WOLF CREEK

WM 96-0112

Reference: 1) Letter WO 95-0178 dated December 13, 1995, from
O. L. Maynard, WCNOG, to the NRC
2) NRC Letter dated August 20, 1996, from J. C. Stone,
NRC, to N. S. Carns, WCNOG
Subject: Docket No. 50-482: Response to Request for Additional
Information Regarding Electrical Power Systems - D.C.
Power Sources and Onsite Power Distribution

Response to Request for Additional Information

FIGURE 1

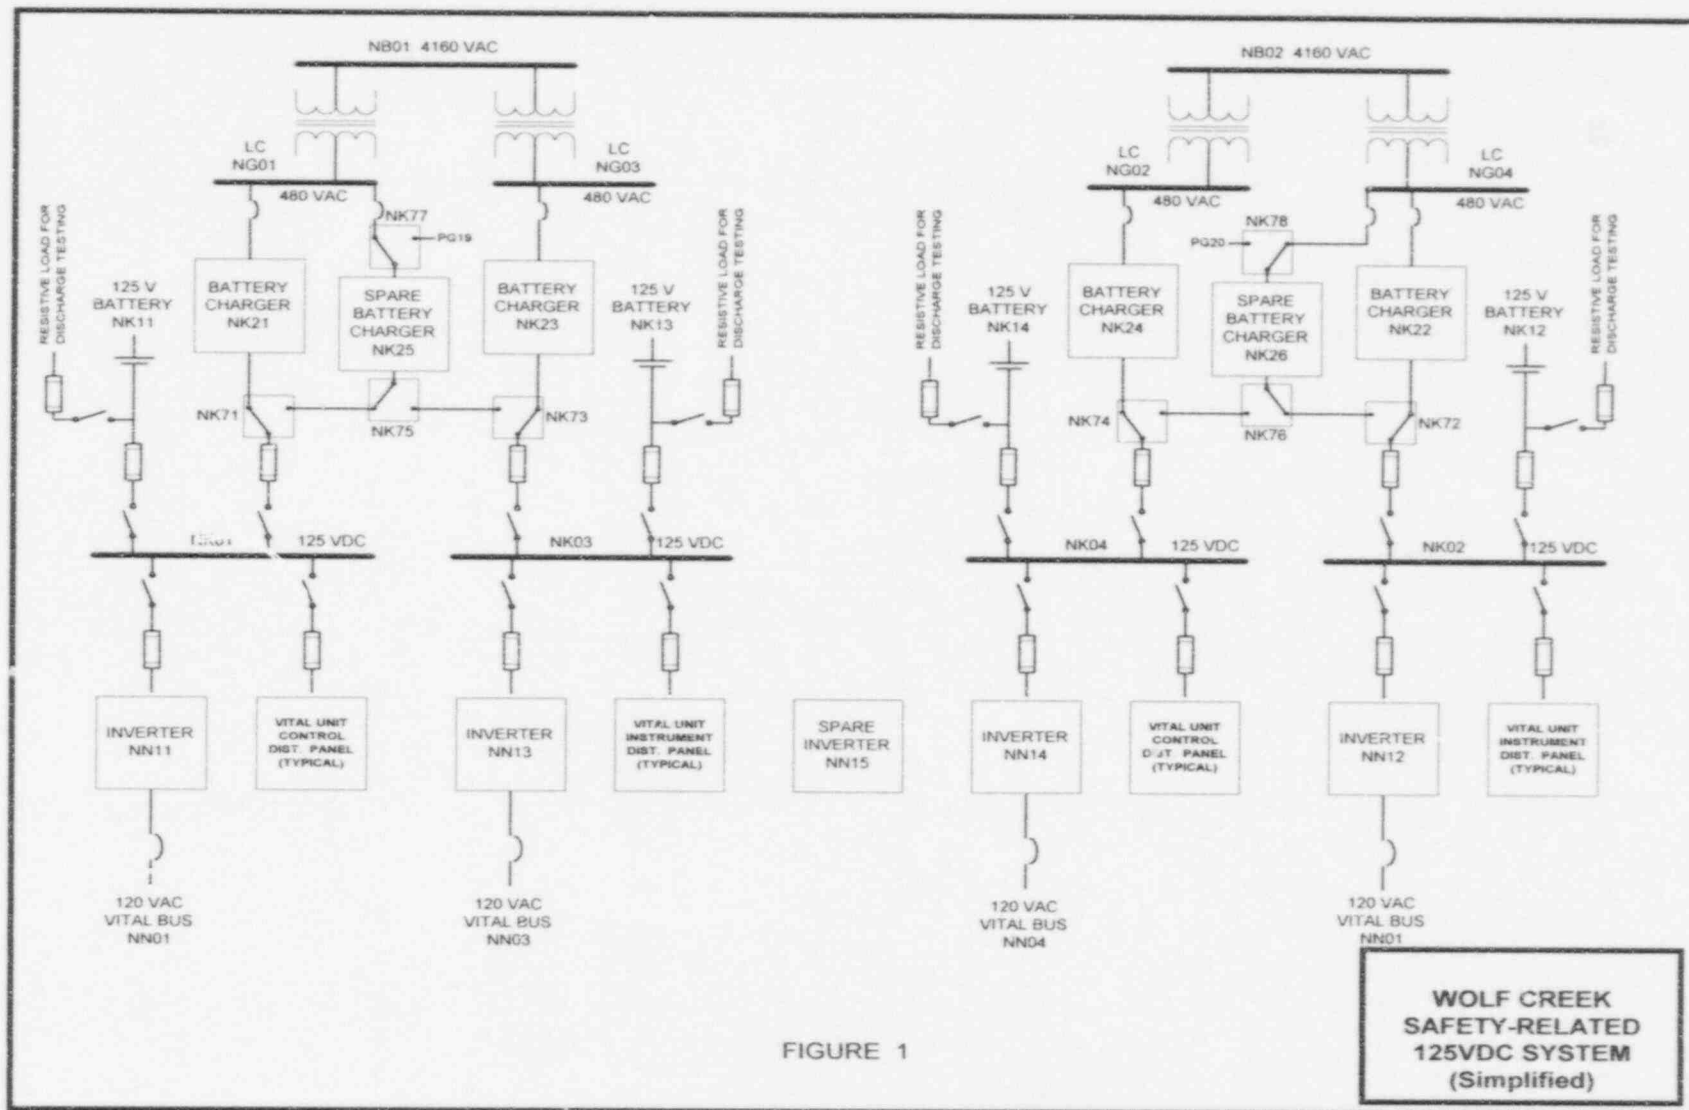
"Please explain how this modification meets the requirements of IEEE-308-1974, 'IEEE Standard Criteria for Class 1E Power Systems for Nuclear Power Generating Stations.' Your response should include but not be limited to the following sections of IEEE-308:

- a. Section 5.3.1(4), Common Power Supplies. This section allows common power supplies for two or more load groups, provided the consequences of the loss of the common power supply has been evaluated and are acceptable. Explain how this section is met and include a discussion of the consequences of the loss of the common power supply to the load groups under design basis conditions.
- b. Section 5.3.4(4), Battery Charger Supply Independence. This section requires the battery charger to have a supply that is independent of other battery chargers. Explain how this section is met with the two chargers connected to the same supply."

The Class 1E, 125 Volt DC system at WCGS consists of two separate redundant load groups with two 125 Volt DC battery chargers in each group. Each load group is powered from an independent, Class 1E, 4160 Volt AC bus (See Figure 1). Each 4160 Volt AC bus provides power to two Class 1E, 480 Volt AC buses. One Class 1E, 125 Volt DC battery charger is powered from each of the Class 1E, 480 Volt AC buses. One Class 1E, 125 Volt DC distribution panel is supplied by each charger.

The proposed swing charger modification will add one spare battery charger to each redundant load group. In the "A" group, the spare charger will be powered from the Class 1E, 480 Volt AC bus, NG01. In the "B" group, the spare charger will be powered from the Class 1E, 480 Volt AC bus, NG04. Output from the spare charger can be connected via transfer switches to either of the two 125 Volt DC distribution panels within the load group. This allows the spare battery charger to be substituted for either of the preferred chargers within the load group.

Under one connection configuration, 480 Volt AC power from one bus will be provided to both 125 Volt DC battery chargers within the same load group. The loss of the 480 Volt AC bus would result in the loss of both chargers within

that load group while in that connection configuration. The redundant load group would be unaffected. This design meets the requirements of paragraphs 5.3.1(4) and 5.3.4(4) of IEEE-308-1974, since the two redundant load groups do not share a common power supply.
